RAM 600-1-507 **NORTHEAST OUTER LOOP** (SR 117) (PHOENIX URBAN AREA)  
(PRICE ROAD DRAINAGE TUNNEL)

Addendum (1)  
RAM 600-1-507  
Sheet 1 of 10  
November 20, 1987

Addendum (2)  
RAM 600-1-507  
Sheet 1 of 1  
December 3, 1987

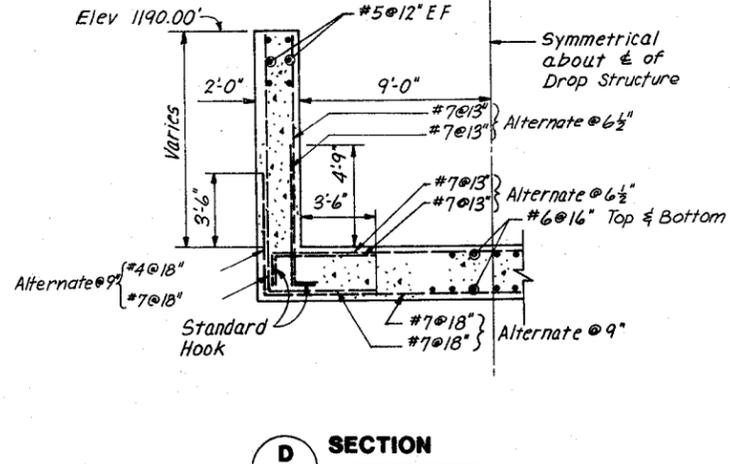
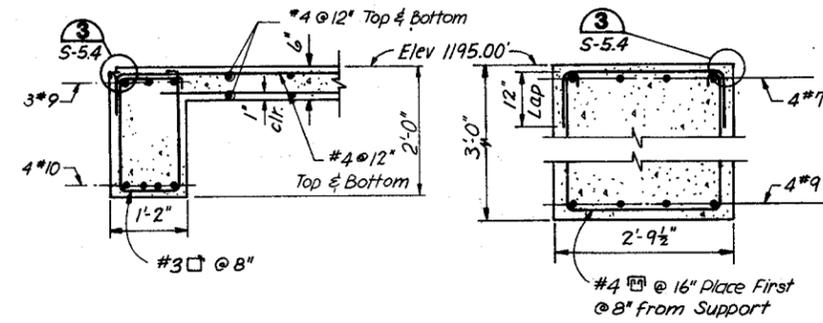
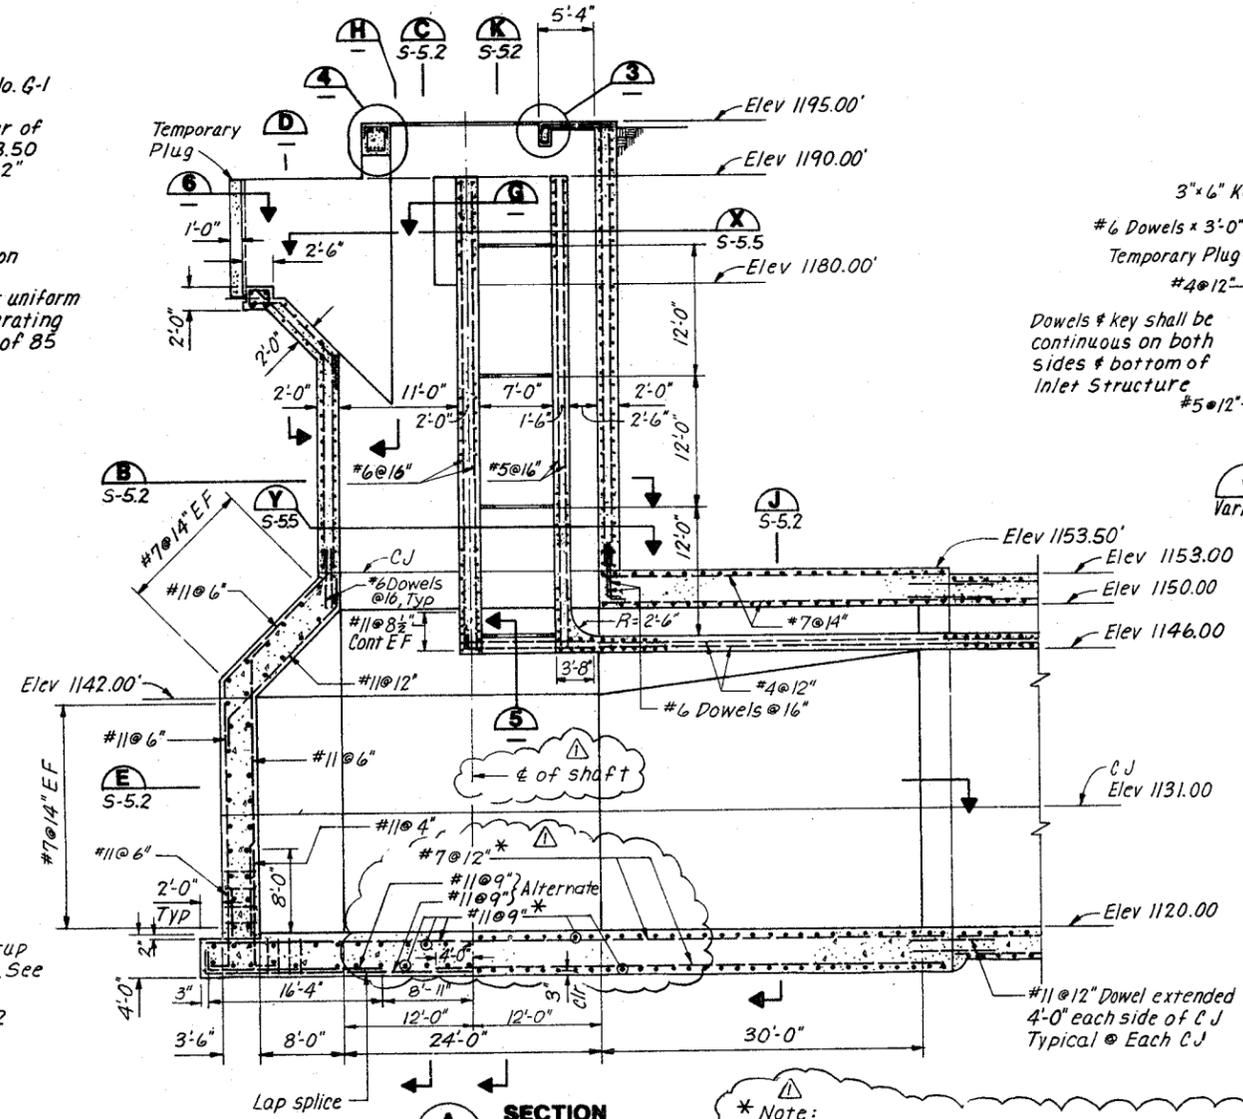
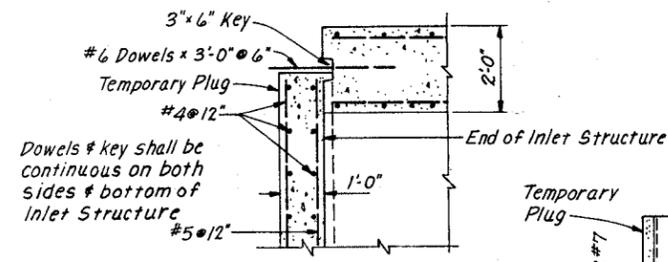
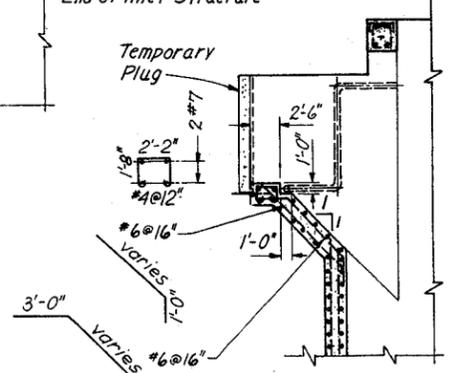
1. DWG No. S-2 In Note 4, Delete the words "Location of dropshaft" and replace with "Ringbeam".
2. DWG No. S-5.1 This drawing has been reissued. Please exchange the original sheet with it's replacement included in this addendum.

2. Dwg. No. C-11

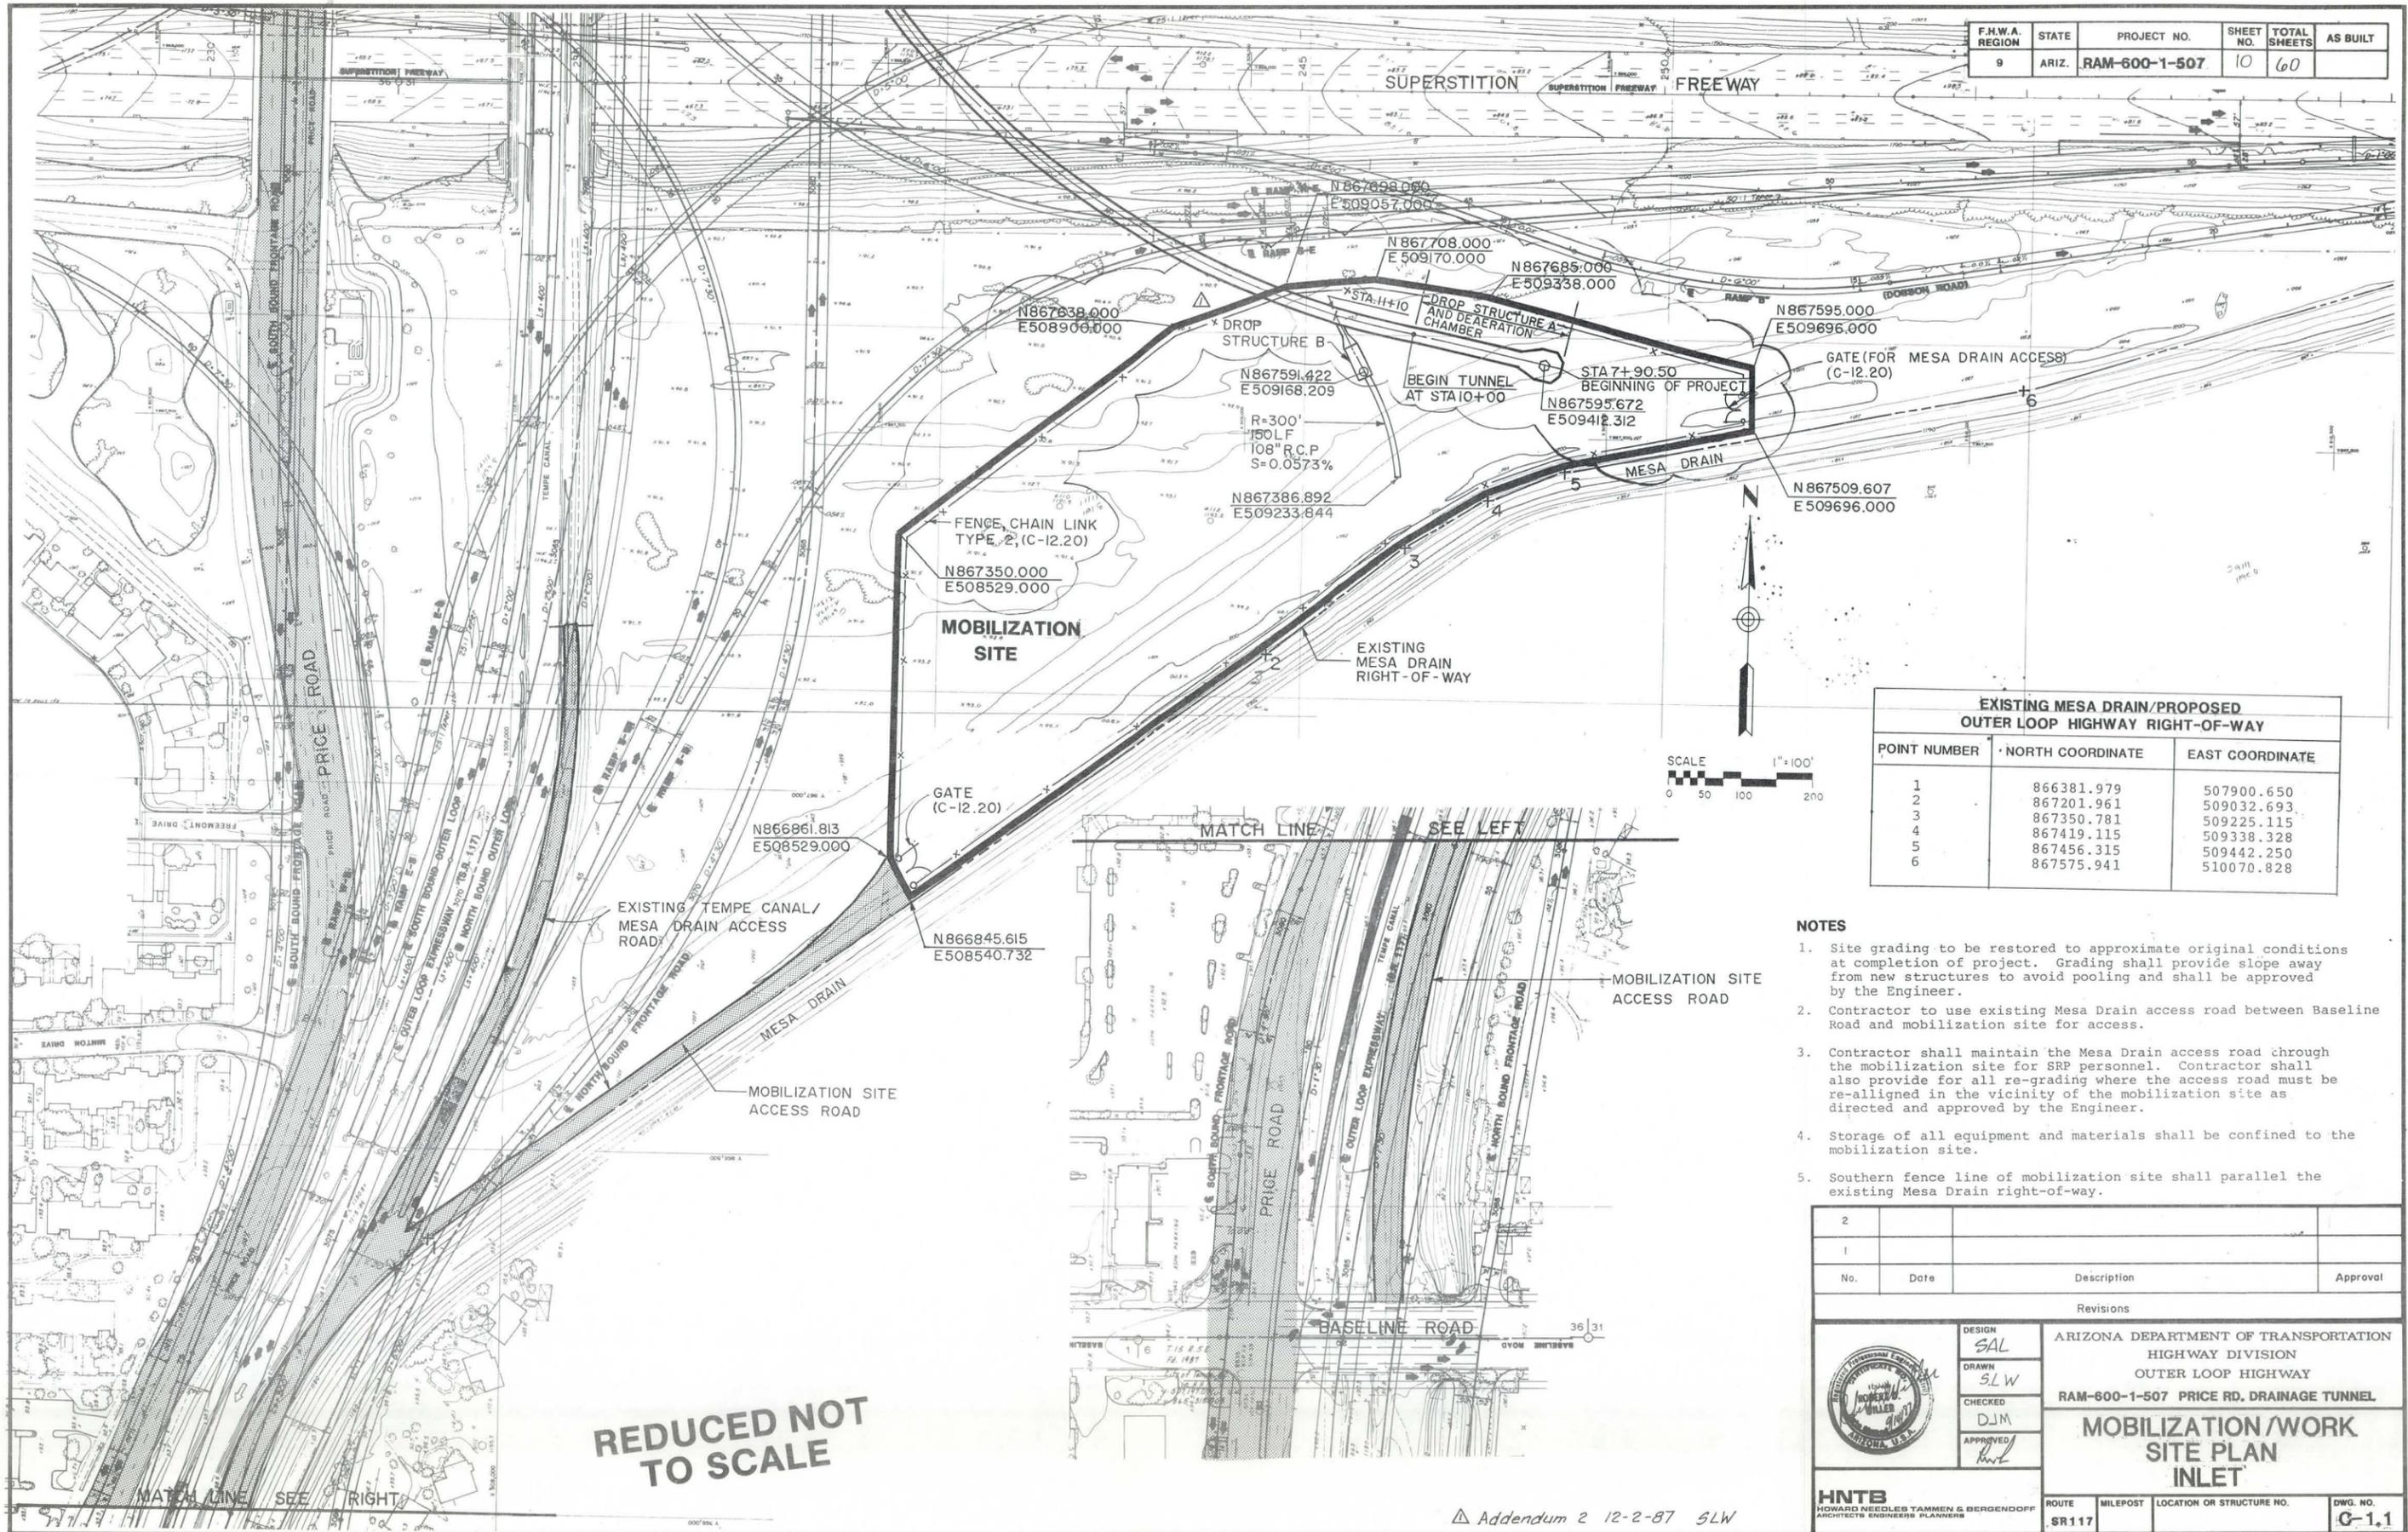
This drawing has been revised. Please exchange the original sheet with its replacement included in this addendum.
